Serial No. 10-047A  
LIC/JG/R0  
Docket No.: 50-305  
License No.: DPR-43

**DOMINION ENERGY KEWAUNEE, INC.**  
**KEWAUNEE POWER STATION**  
**SUPPLEMENT 1 TO LICENSE AMENDMENT REQUEST 246: REVISION TO**  
**REACTOR COOLANT SYSTEM PRESSURE AND TEMPERATURE LIMITS AND**  
**LOW TEMPERATURE OVERPRESSURE PROTECTION LIMITATIONS**

**LICENSE AMENDMENT 246  
SUPPLEMENT 1  
REACTOR COOLANT SYSTEM PRESSURE AND TEMPERATURE LIMITS AND  
LOW TEMPERATURE OVERPRESSURE PROTECTION**

**DISCUSSION OF CHANGE**

Figure 3.4.3-1 (page 1 of 1)  
 KPS Heatup, Criticality, and In-Service Leak Test Limitation Curves  
 Applicable for Periods up to 52.1 33<sup>(1)</sup> Effective Full Power Years (EFPY)

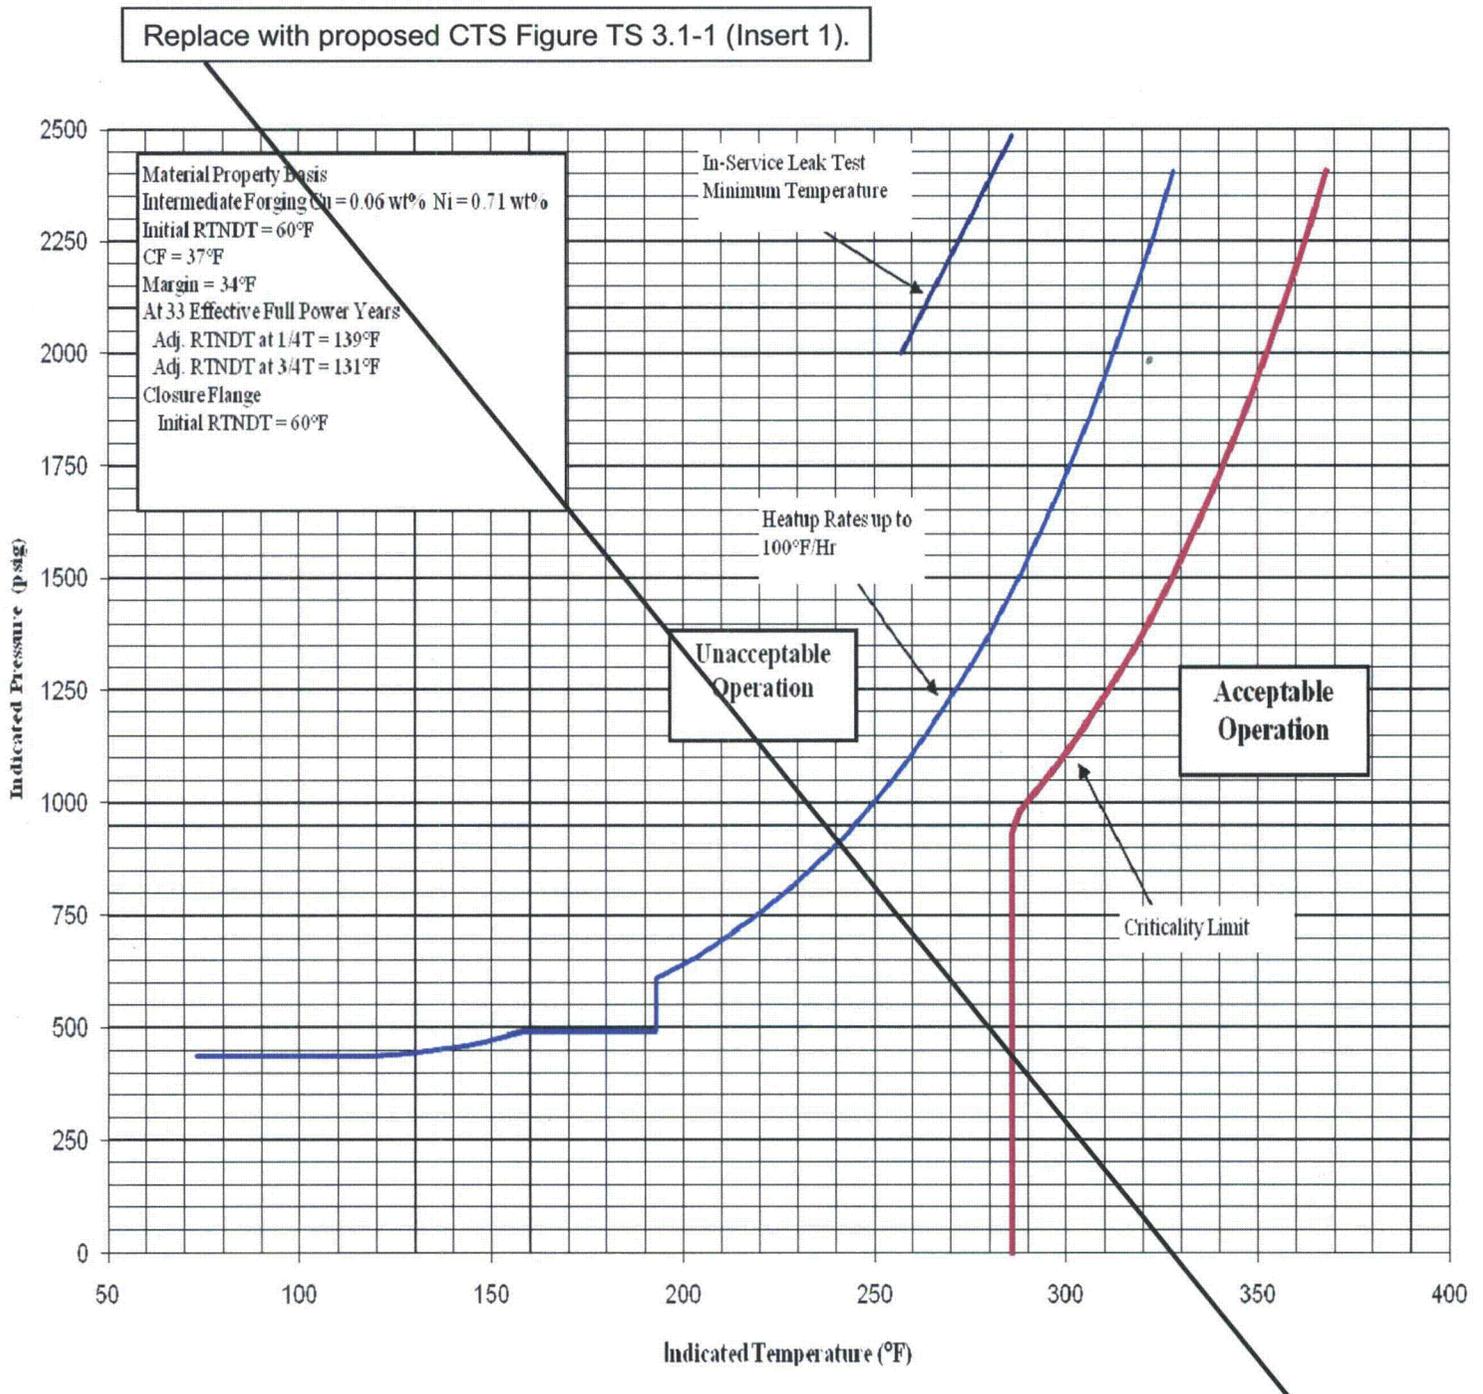
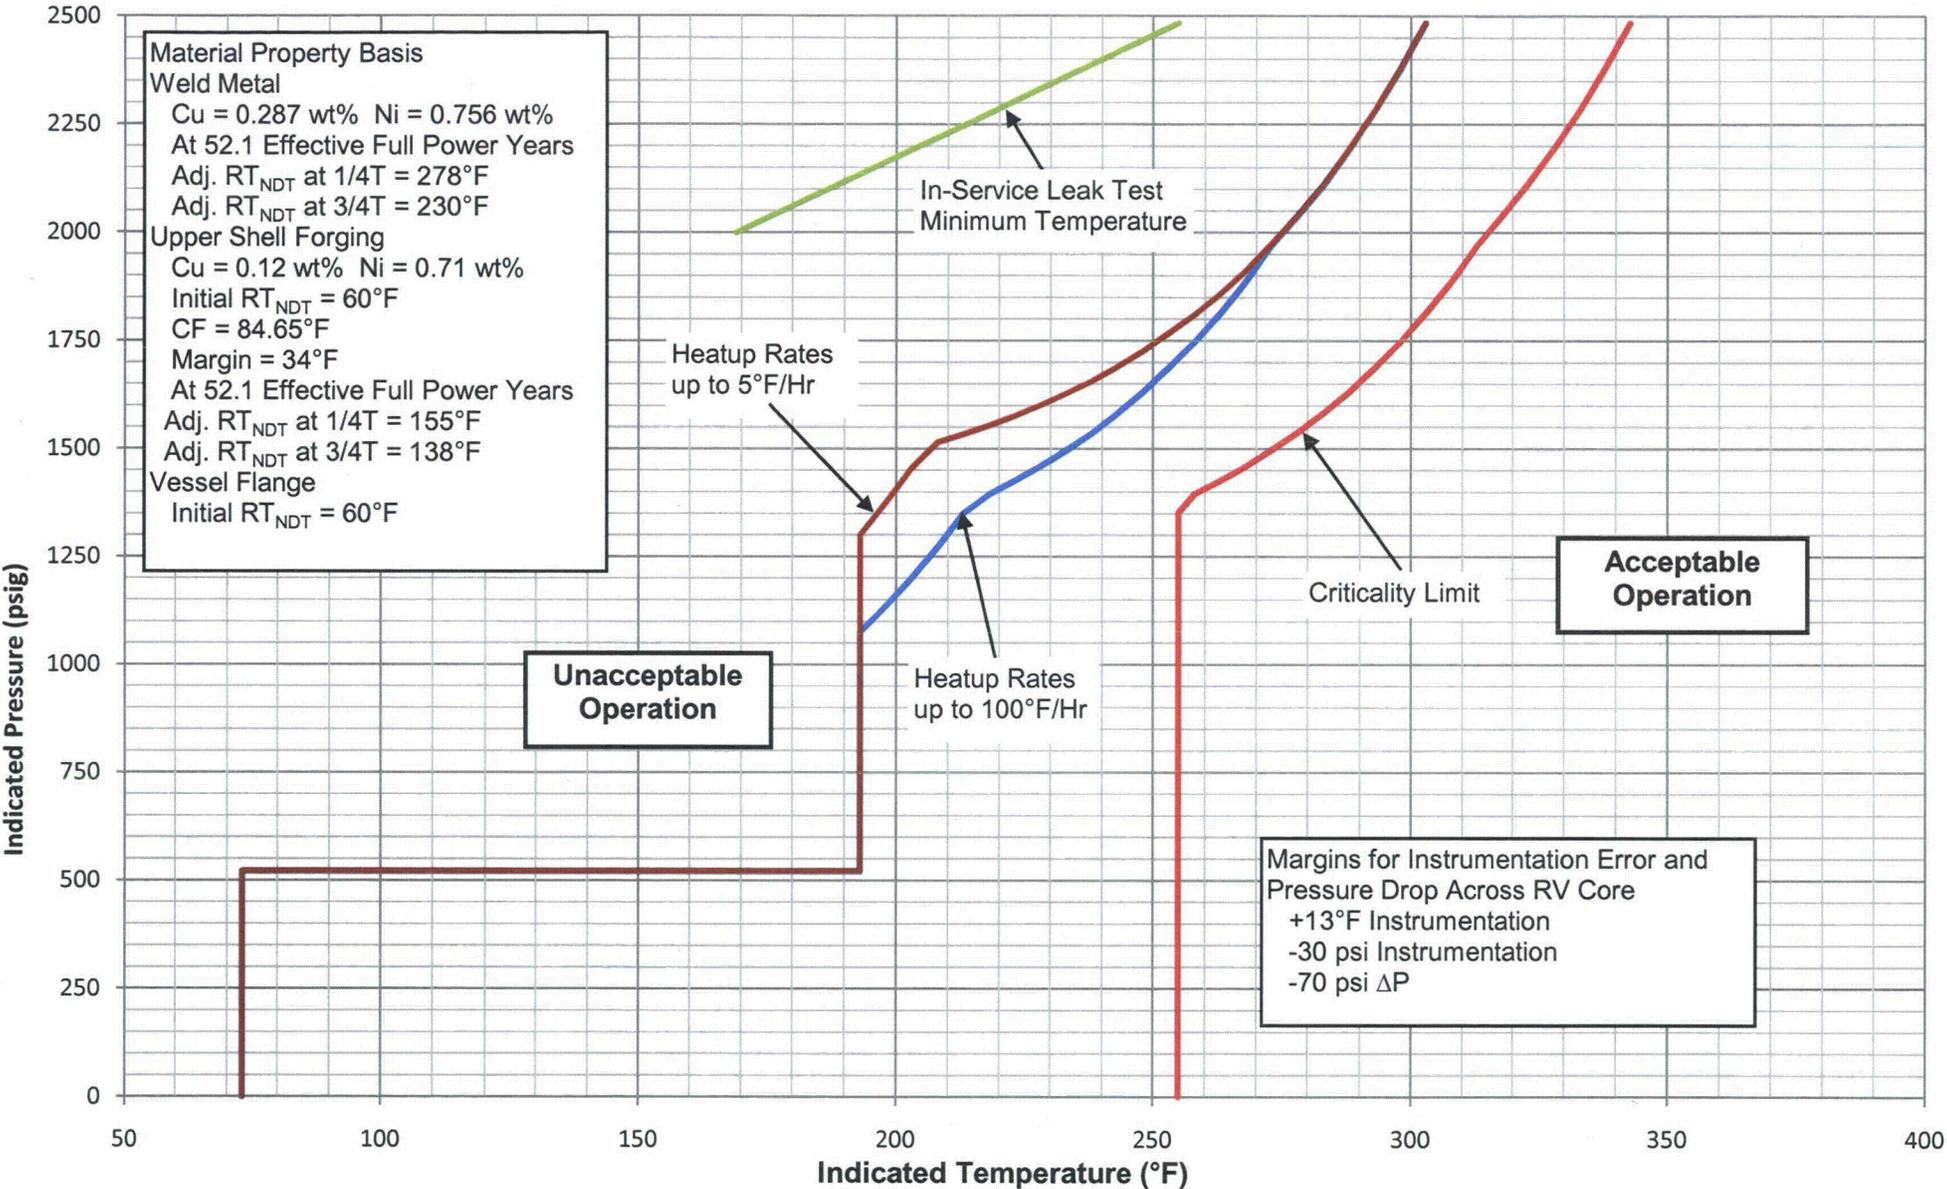
The new heatup and cooldown pressure-temperature (P/T) limit curves provided in the originally submitted LAR 246 (CTS Figure TS 3.1-1 and CTS Figure TS 3.1-2) replace ITS Figure 3.4.3-1 and ITS Figure 3.4.3-2, respectively. The amendment also extends the applicability of the P/T limit curves through 52.1 effective full power years (EFPY) as originally submitted in LAR 246, which is the expected period of a KPS extended license. Accordingly, the existing note beneath ITS Figure 3.4.3-1 and ITS Figure 3.4.3-

2 limiting the curves to 31.1 EFPY is deleted. This change is administrative because it only converts the new P/T limit curves in the originally submitted LAR 246 into the format and structure of ISTS.

(1) Curves limited to 31.1 EFPY due to changes in vessel fluence associated with operation at power uprate

Figure 3.4.3-1 (page 1 of 1)  
KPS Heatup, Criticality, and In-Service Leak Test Limitation Curves  
Applicable for Periods up to 52.1 Effective Full Power Years (EFPY)

Figure 3.4.3-2 (page 1 of 1)  
 KPS Cooldown and LTOP Event Limitation Curves  
 Applicable for Periods up to 52.1 ~~33~~<sup>(4)</sup> EFPY

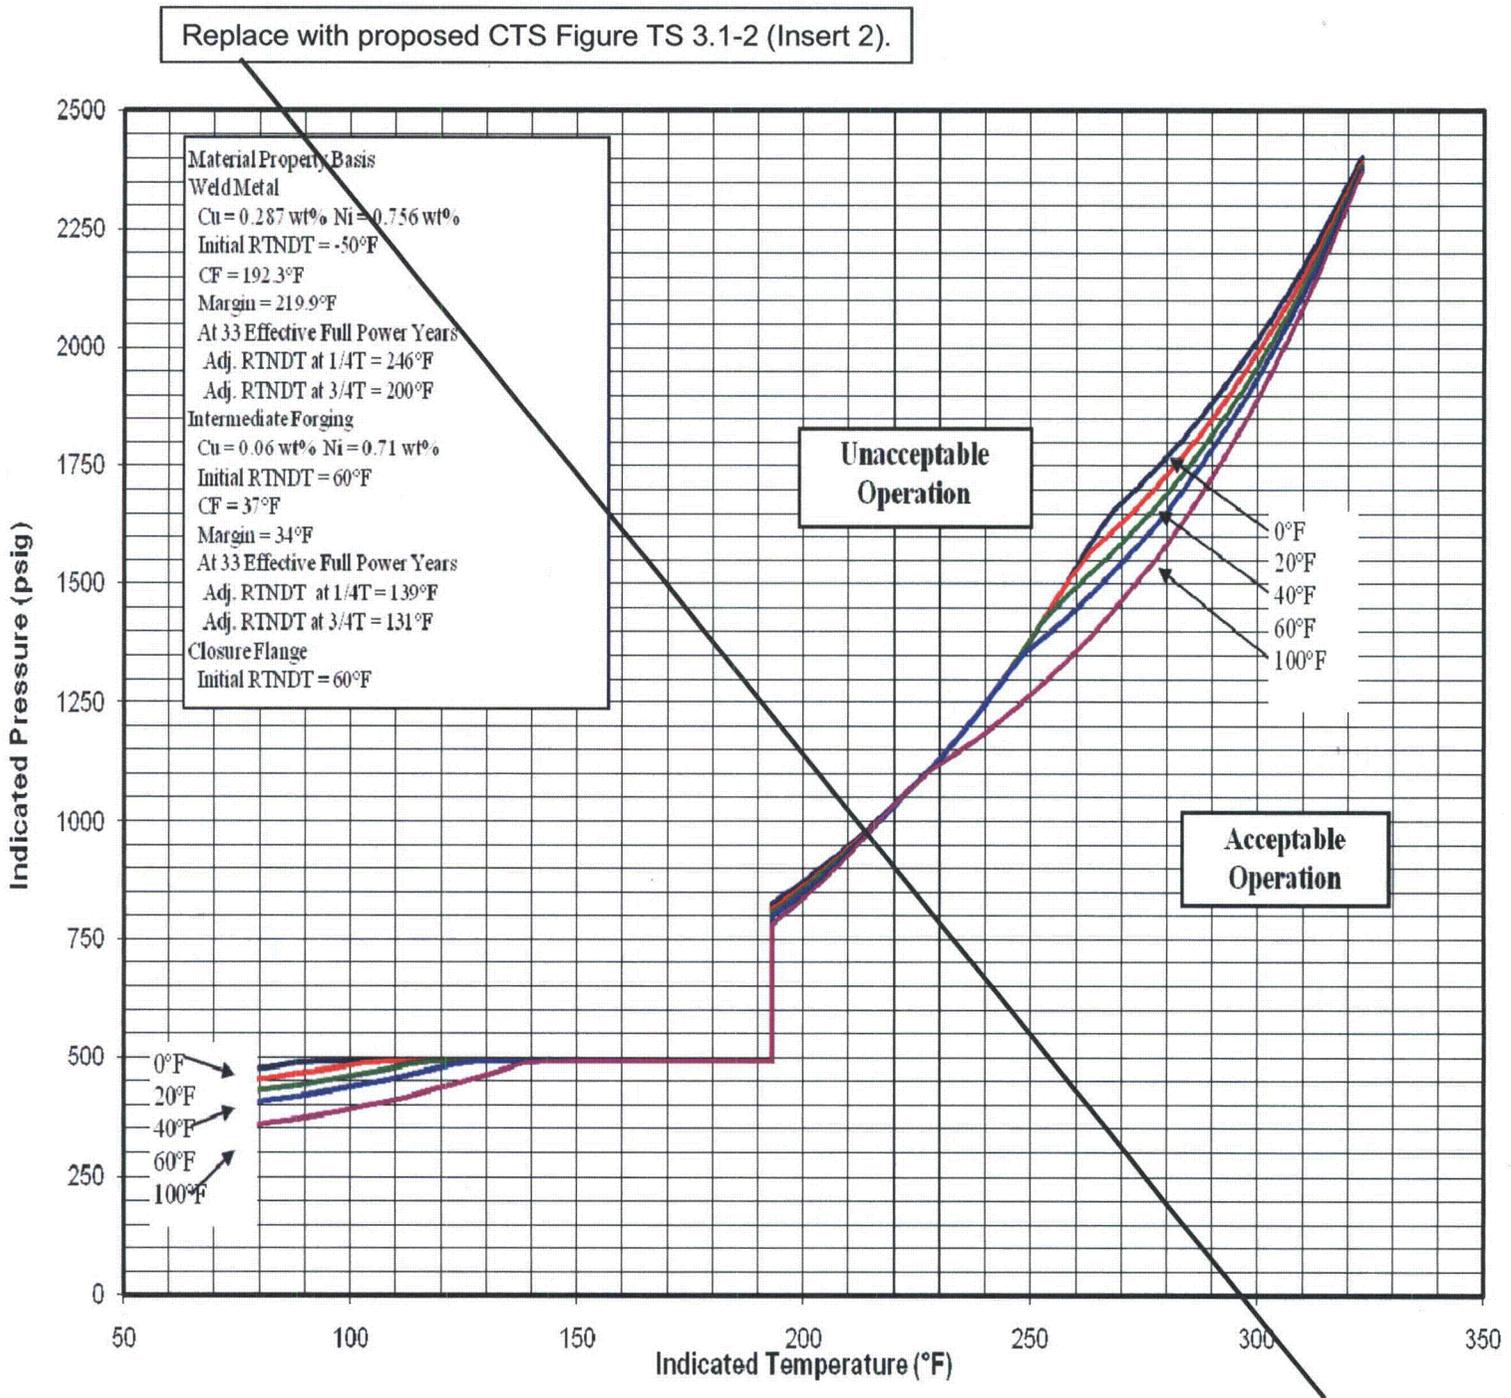
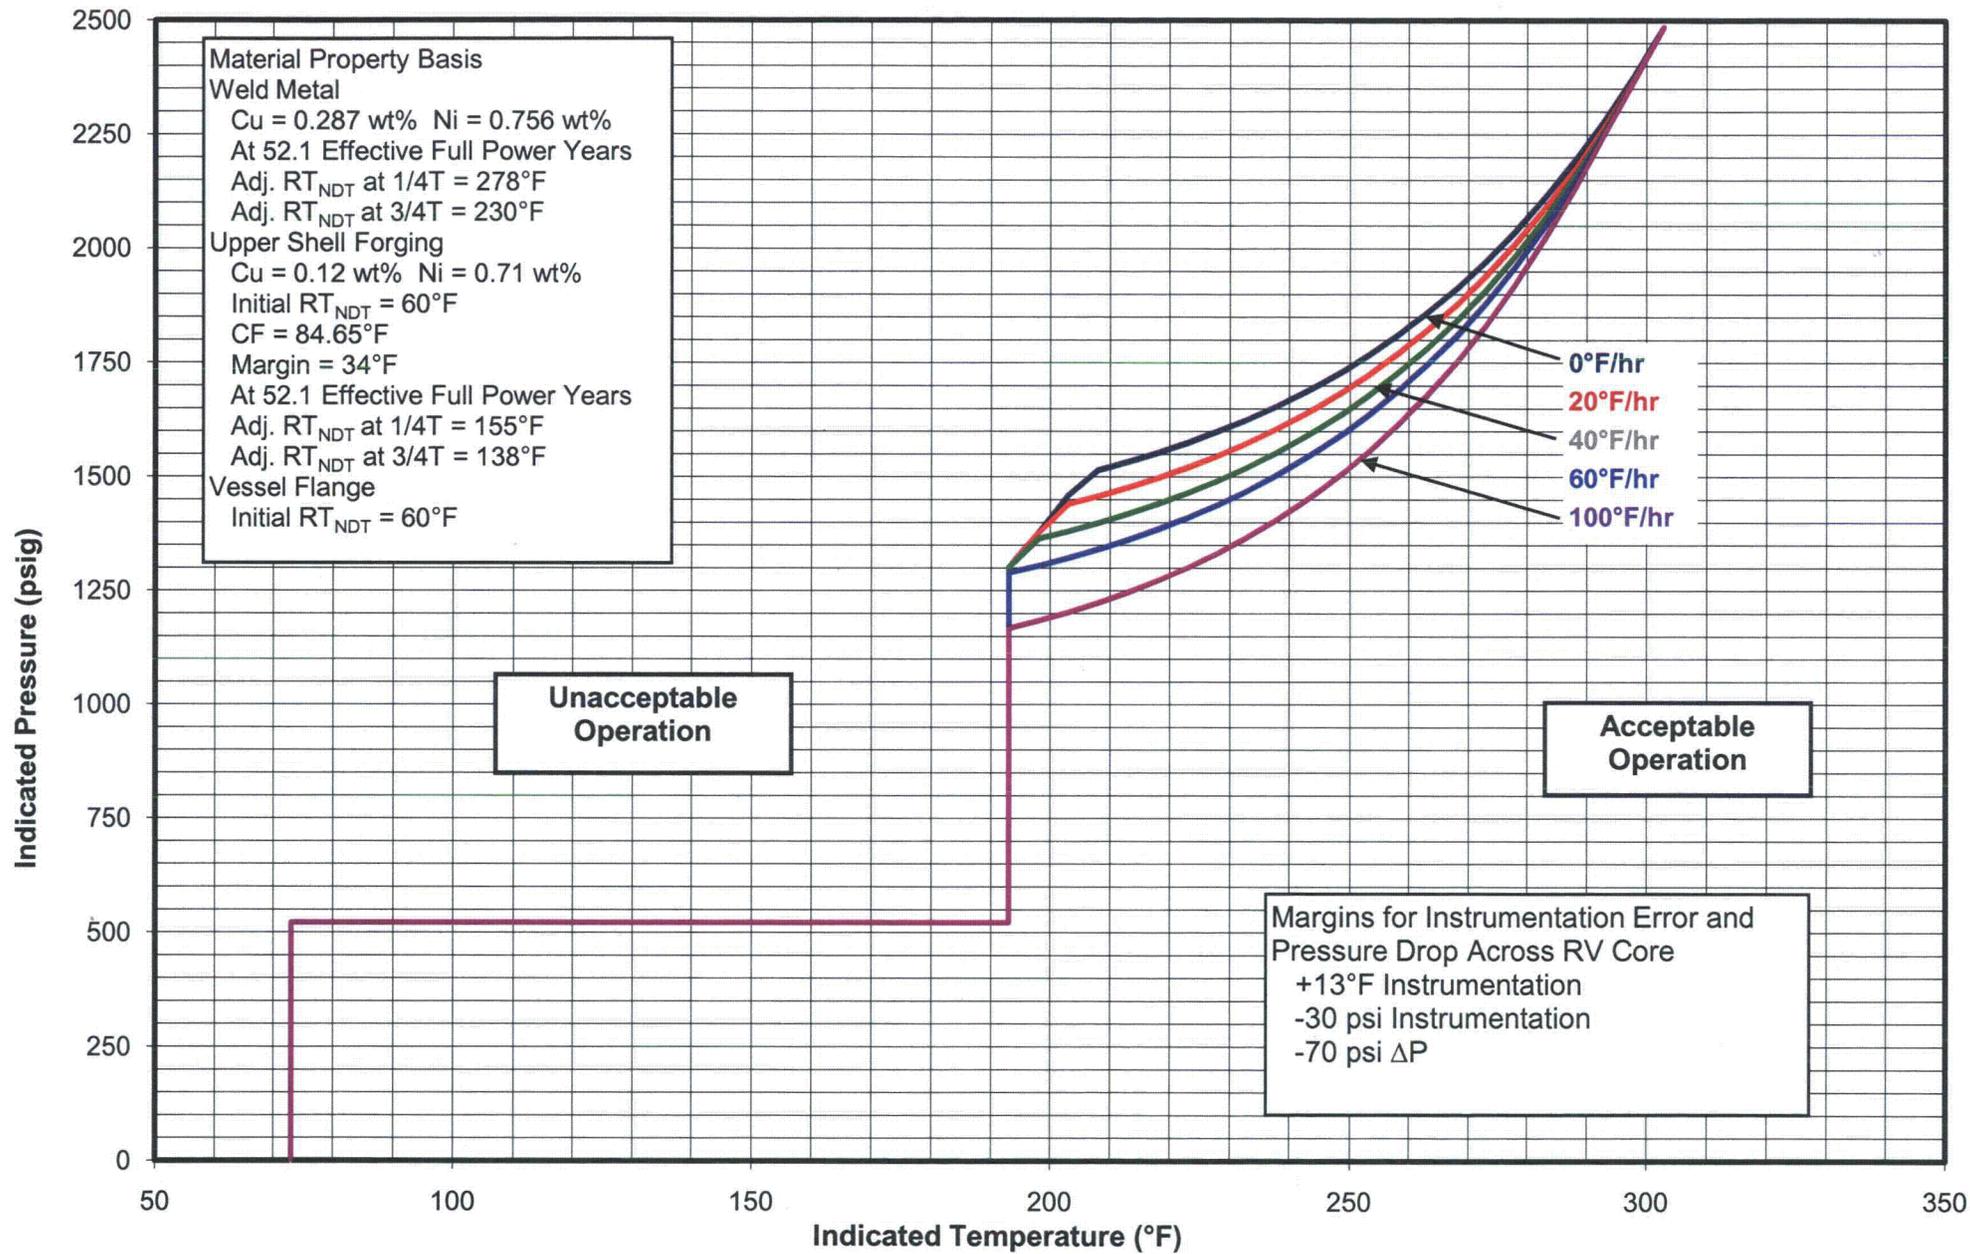
(1) ~~Curves limited to 31.1 EFPY due to changes in vessel fluence associated with operation at power uprate~~

Figure 3.4.3-2 (page 1 of 1)  
KPS Cooldown and LTOP Event Limitation Curves Applicable for Periods up to 52.1 EFPY
